CITY OF GRAND HAVEN
GRAND HAVEN, MICHIGAN
PLANNING COMMISSION
MEETING AGENDA
September 15, 2026

DATE: September 11, 2026
TO: Grand Haven Planning Commission
FROM: Brian Urquhart, City Planner
RE: Case 26-29: 700 Robbins Rd. Site Plan

DATE: September 11, 2026
TO: City of Grand Haven Planning Commission
FROM: Brian Urquhart, City Planner
RE: 601 S. Beechtree Site Plan

DATE: September 10, 2026
TO: City of Grand Haven Planning Commission
FROM: Brian Urquhart, City Planner
RE: 224 Washington Ave. (former Jewelry building)

SITE LAYOUT PLAN

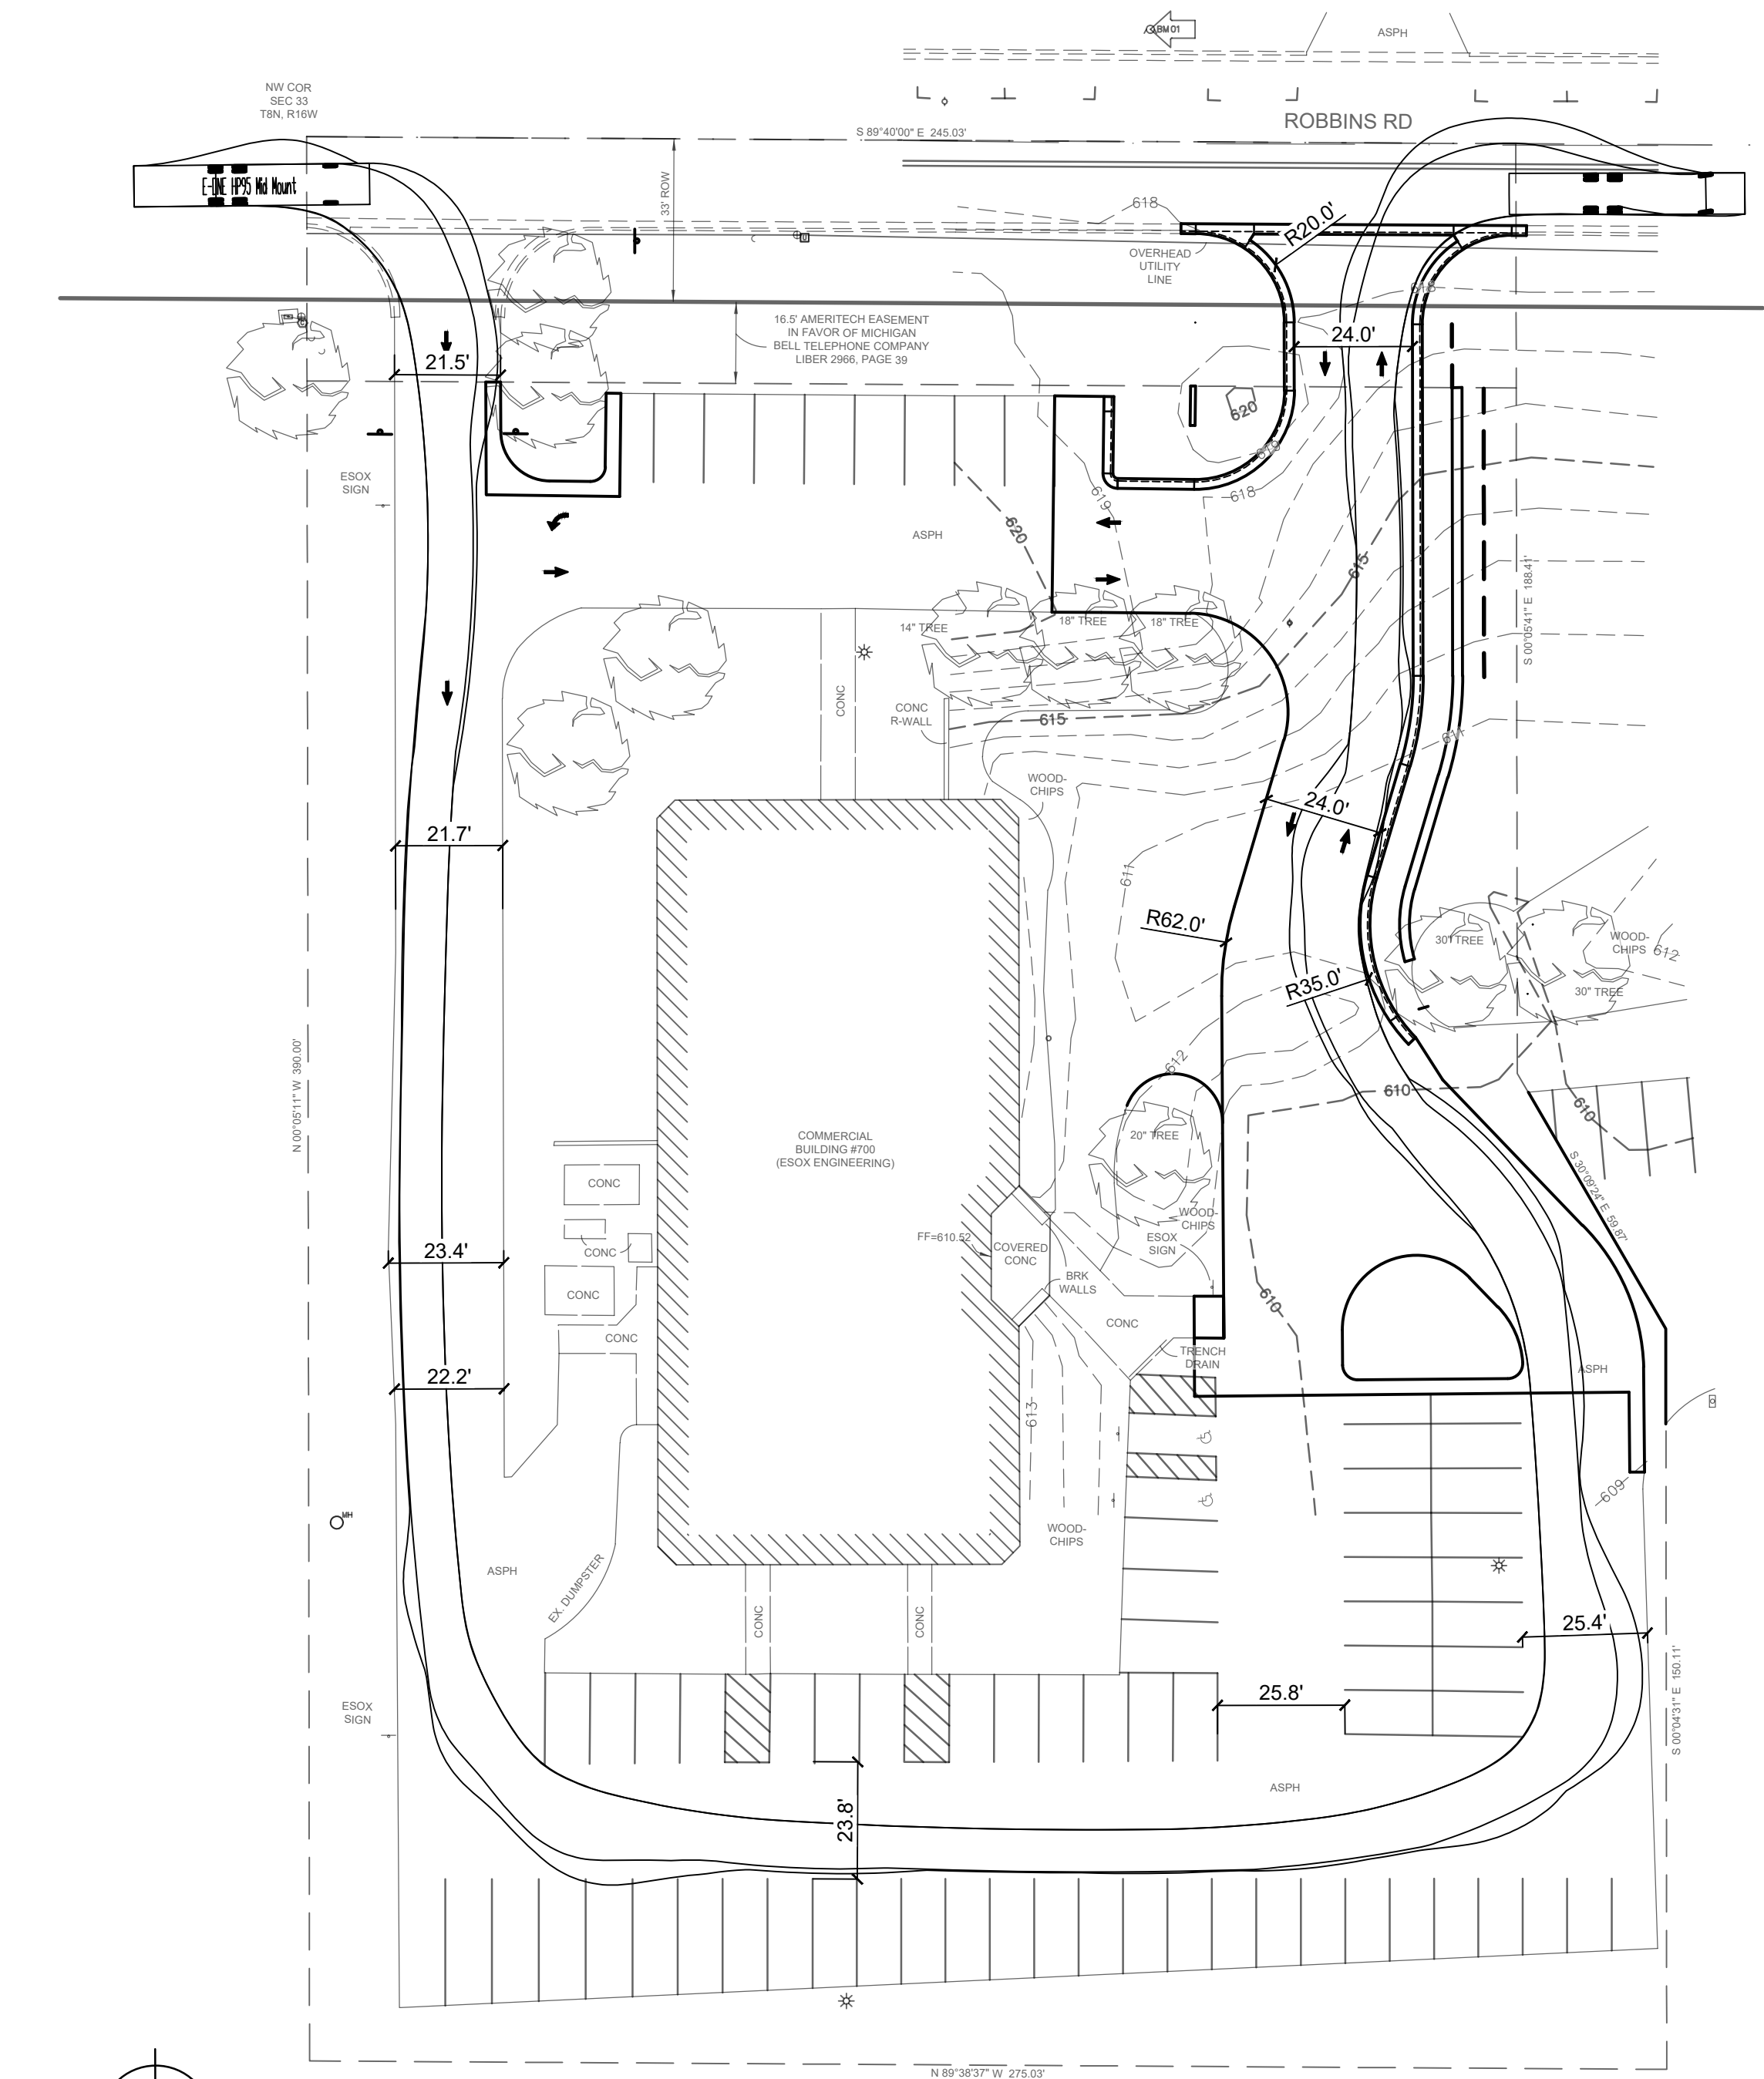
A sidewalk is proposed along the south side of Robbins Rd. for the South Village PD. In order to maintain connectivity for nonmotorized uses, it is recommended the site plan is amended to include sidewalk along the entire length of the north property line in front of 700 Robbins.

Landscaping. Street trees will be planted along the north property as required. Along the east side of the drive trees, shrubs, and ground cover are shown, delineating 700 Robbins Rd. from South Village PD.

1. *Site plan shall be amended to include sidewalk shown along the entire length of the north property line.*
2. *All conditions of the BLP, DPW and Fire Marshal shall be met.*
3. *(Insert any additional conditions as necessary)*

SITE PLAN (9-UNITS)
SCALE: 1" = 40'

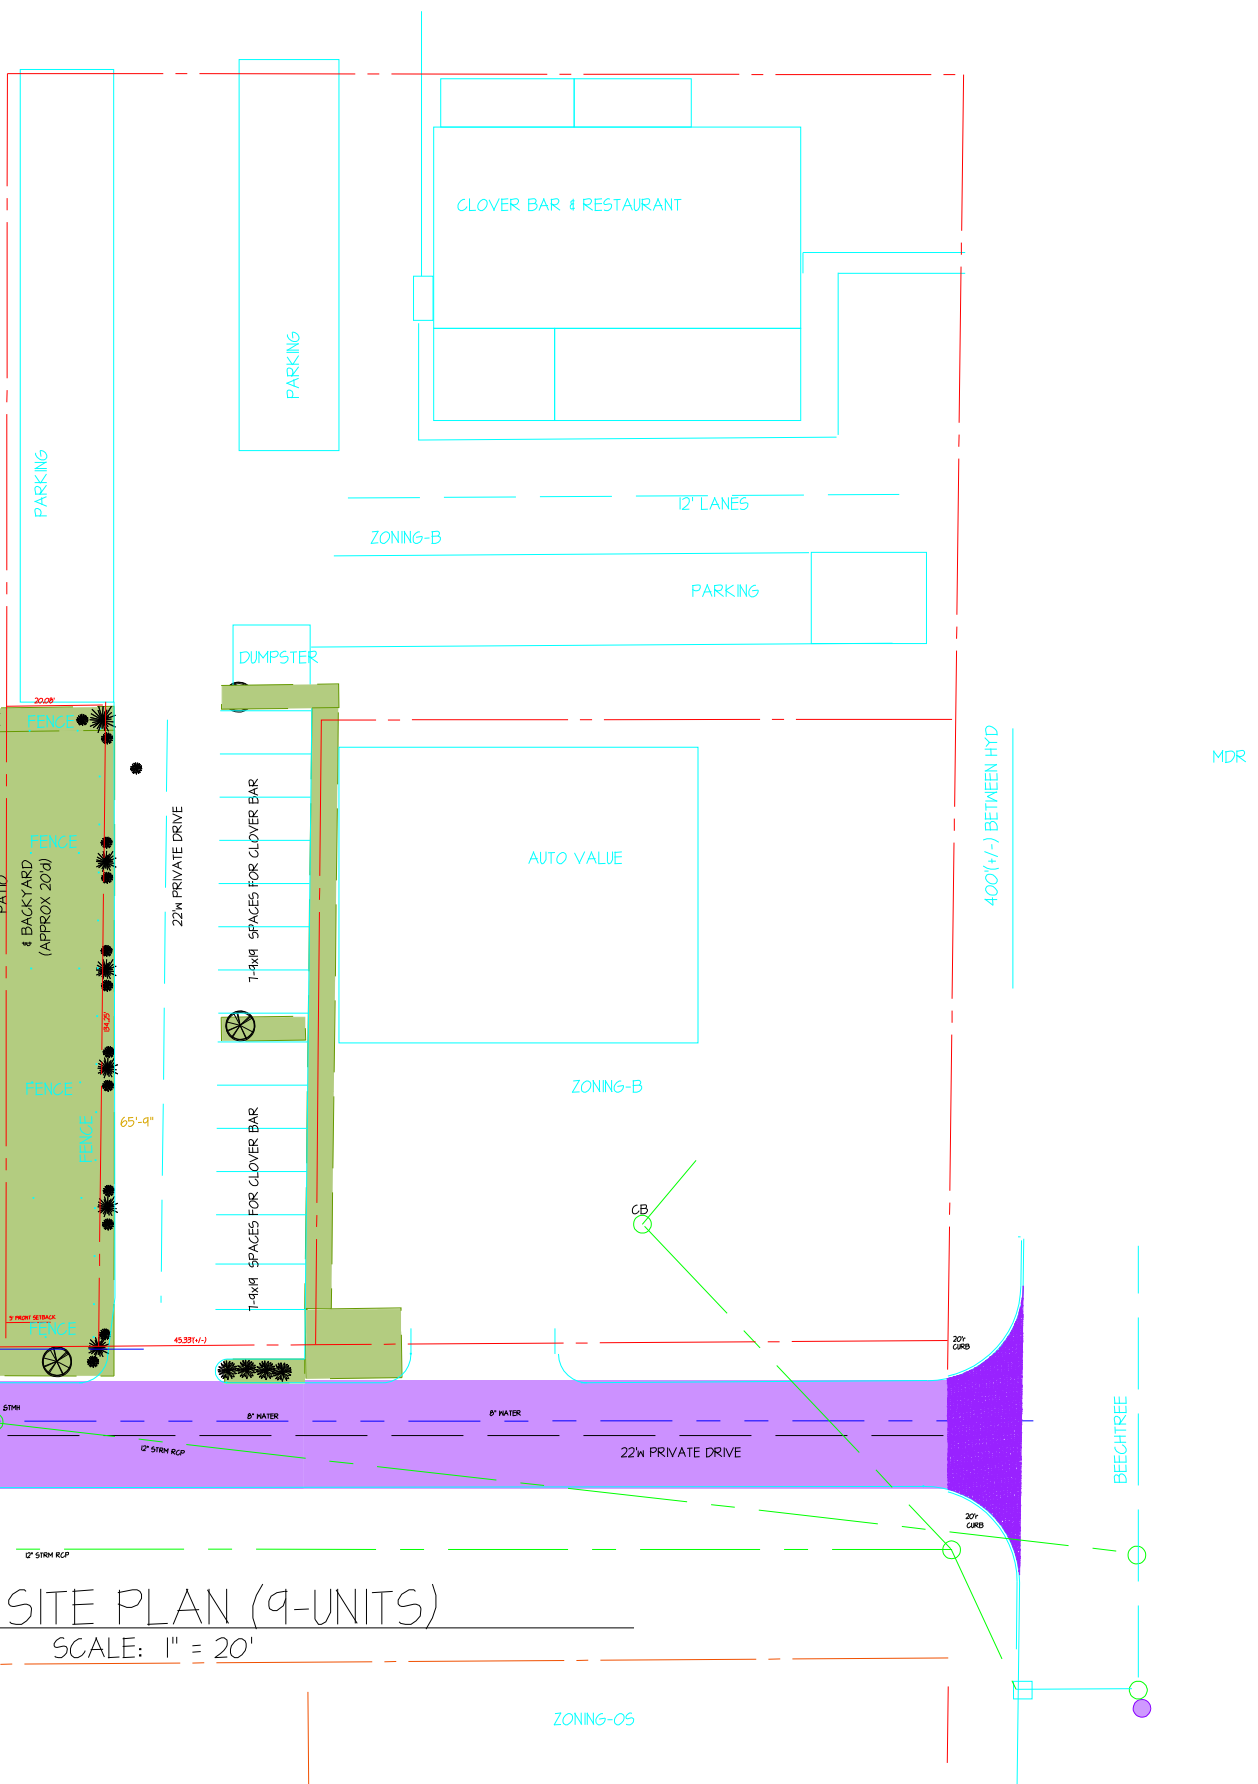
The preliminary plan calls for landscape screening along the north of the parking lot, screening from the property to the north. The plans also depict lawn area and tree and shrub planting throughout the area.

The most important factor for the mixed-use development is access. The plan to include a driveway within the right-of-way would rest with City Council upon recommendation from the respective city departments. The plan does call for a 22 ft. wide drive just east of the development, providing access off Waverly Rd.

Per Sec. 40-306.01, the parcel will also need to be split, as no more than 1 principal use per lot is permitted. Clover Bar is planned to remain, and thus a different principal use on the same lot.
